APPLICATION NO.	FILING DATE	FIRST NAMED INVENTOR	ATTORNEY DOCKET NO.	CONFIRMATION NO.
10/600,479	06/19/2003	Seiya Asano	3702/0M969US0	6321
7278	7590	06/30/2005	EXAMINER	
DARBY & DARBY P.C. P. O. BOX 5257 NEW YORK, NY 10150-5257			NGUYEN, XUAN LANT	
			ART UNIT	PAPER NUMBER
			3683

Office Action Summary	Application No. 10/600,479	Applicant(s) ASANO ET AL	
	Examiner Lan Nguyen	Art Unit 3683

3. Claims 1-3 are rejected under 35 U.S.C. 103(a) as being unpatentable over Nicholson (GB 2364558 A) in view of Noboru et al. (JP 11-153180).

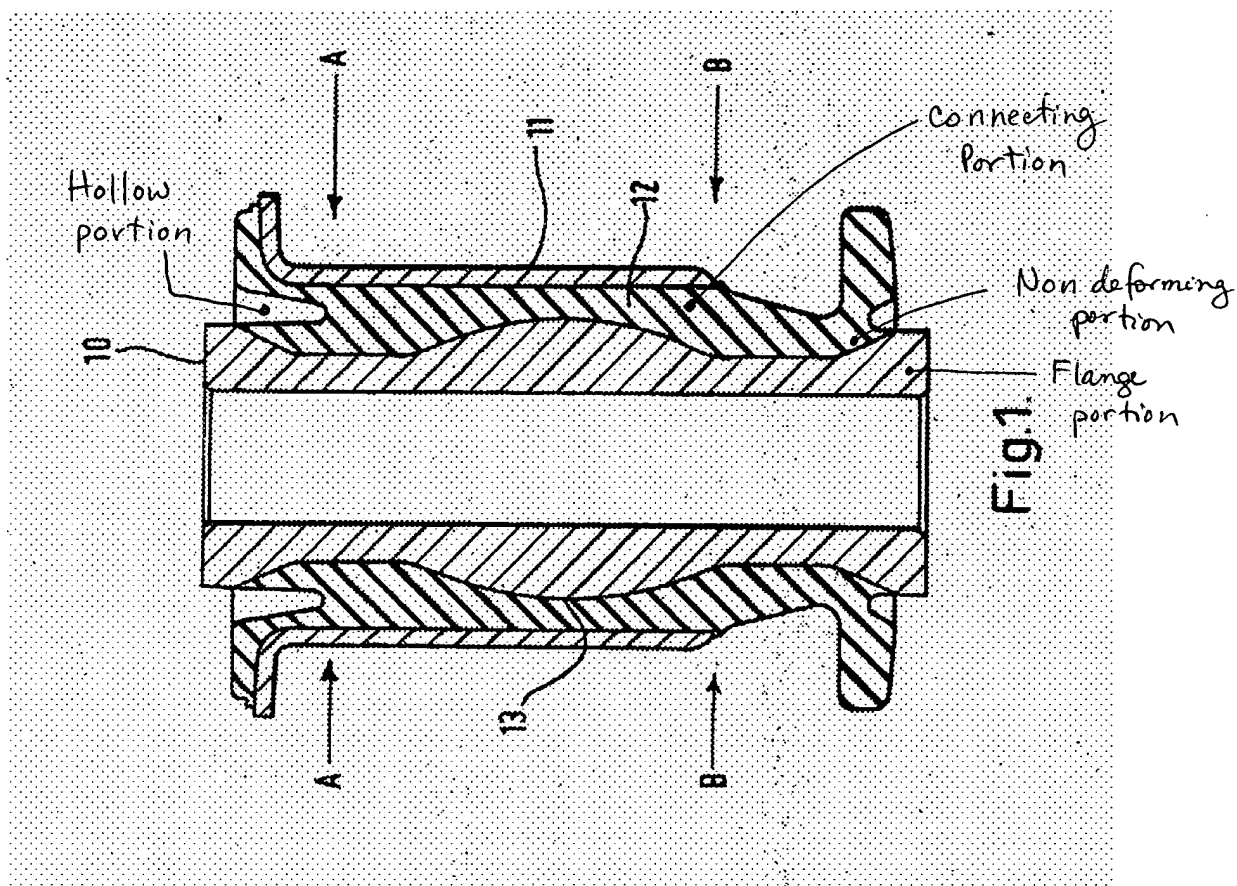
Re: claim 1, Nicholson shows a vibration isolating bushing in figure 1, as in the present invention, comprising: a main shaft member 10 including a tubular portion, a flange portion, as marked below, extending radially outwardly from one end of the tubular portion, and a block portion 13 provided on a central portion of the tubular portion and distanced from the flange portion in an axial direction of the main shaft member; an outer cylinder member 11 disposed coaxially on an outer side of the main shaft member in a distance therefrom; and a rubber elastic body 12 disposed between the main shaft member and the outer cylinder member integral connection of the main shaft member and the outer cylinder member, said rubber elastic body including a hollow portion, as marked below, which is open in an end face away from the flange

portion and extends in the axial direction; wherein the rubber elastic body further includes non-deforming rubber portion, please see the figure below, and a connecting portion, see the figure below; the non-deforming rubber portion fills a gap between the flange portion and an end face of the block portion facing the flange portion in the axial direction and is substantially undeformable with respect to an application of an axial load; the connecting portion is positioned between a bottom the hollow portion and the end face of the rubber elastic body on the side of the flange portion, for connecting the non-deforming rubber portion and an inner peripheral surface of an end portion of the outer cylinder member. Nicholson is silent of the cross-sectional shape of the hollow portion as claimed. Noboru et al. teach a vibration isolation bushing, especially a cross-sectional shape of a hollow portion, in figures 2 and 4. In figure 4, the hollow portion 74 extends to a vicinity of an end face of a block portion 78. In figure 2, the hollow portion 74 directly surrounds the block portion extending circumferentially and over a side surface to the main shaft member 56. It would have been obvious to one of ordinary skill in the art at the time the invention was made to have modified Nicholson's bushing with a hollow portion such as taught by Noboru et al. in order to provide a softer ride since it is well known in the art of dampening to change the spring constant of the elastomer member in order to achieve a desired dampening results as evidenced by Norobu et al.

Re: claim 2, Nicholson shows the radial outer peripheral surface of the block portion 13 to be located more inwardly than an outer peripheral end of the flange portion.

Re: claim 3, Nicholson further shows the connecting portion to be offset inwardly compared to the non-deforming portion.
